## DRAWINGS

FIG-1

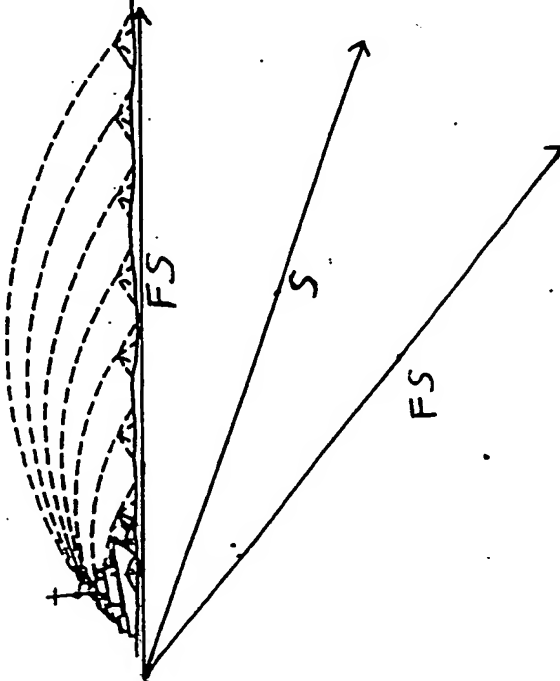
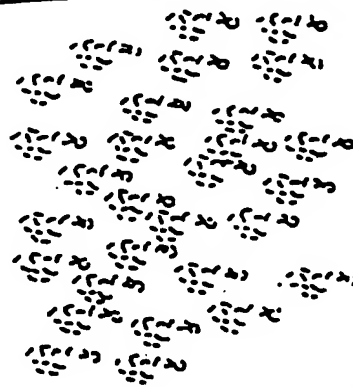
The Patent Office objects to the drawings filed, because they fail to show the deployment of the invention (Figure 1, Stage 1), which states that the invention is deployed from the aft deck of a ship (page 5, lines 6-7), as described in the specification. In response, Applicants have corrected Figure 1, Stage 1 by aligning the ship to show deployment from the aft deck of the ship, such as is shown in Figure 2 and described in the specification as filed. Corrected Stage 1 of Figure 1 shows devices thrown to distances from the aft deck of a ship from the left launcher location, such as is shown in the top view exploded view of aft deck "P" in Figure 2. As a result, and in connection with the prior explanations provided by Applicants, Applicants assert that corrected Figure 1, Stage 1, shows the deployment of the invention from the aft deck of a ship as described at page 5, lines 6-7, and thus, that replacement Figure 1 is in accordance with 37 C.F.R. § 1.83(a) and MPEP § 6.0802(d).
